BE IT REMEMBERED THAT A Regular Meeting of the Planning and Zoning Commission of the City of Sherman, January 22, 2008.

PLANNING AND ZONING COMMISSION

City of Sherman
Planning and Zoning Commission
Board of Adjustments
Agenda Communication Form
January 22, 2008
Jason Sofey, Chairman

REPLAT OF BLOCK B, AUSTIN LANDING ADDITION, PHASE ONE THE CITY OF SHERMAN, TEXAS 7.958 ACRES

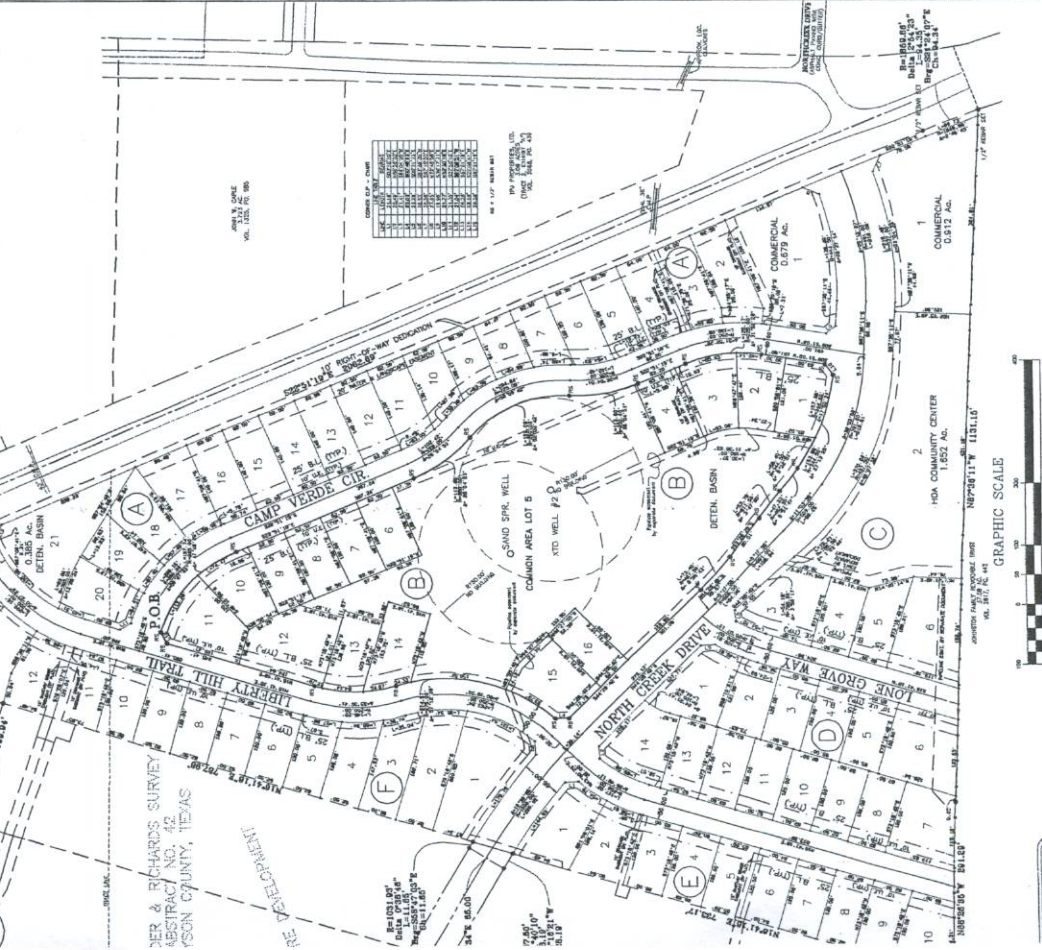
1. Curve data for the replat not shown on drawing for curve located along Liberty Trail in front of Lots 13 and 14.
2. Volume and page of pipeline easements that were recorded by separate document on the replat need to be shown.

6. Field notes need to list the volume and page of original plat.
7. Field note calls that are not listed in the drawing need to be added.
8. Sidewalks and drive approaches are to be to City Standards.

10. Original tax certificates for the property must be furnished prior to recording of the plat.
11. Any other changes made to the Replat prior to the final fulfillment of the conditions of the staff review, must be considered minor by the staff, as to not require resubmission to the Planning and Zoning Commission.
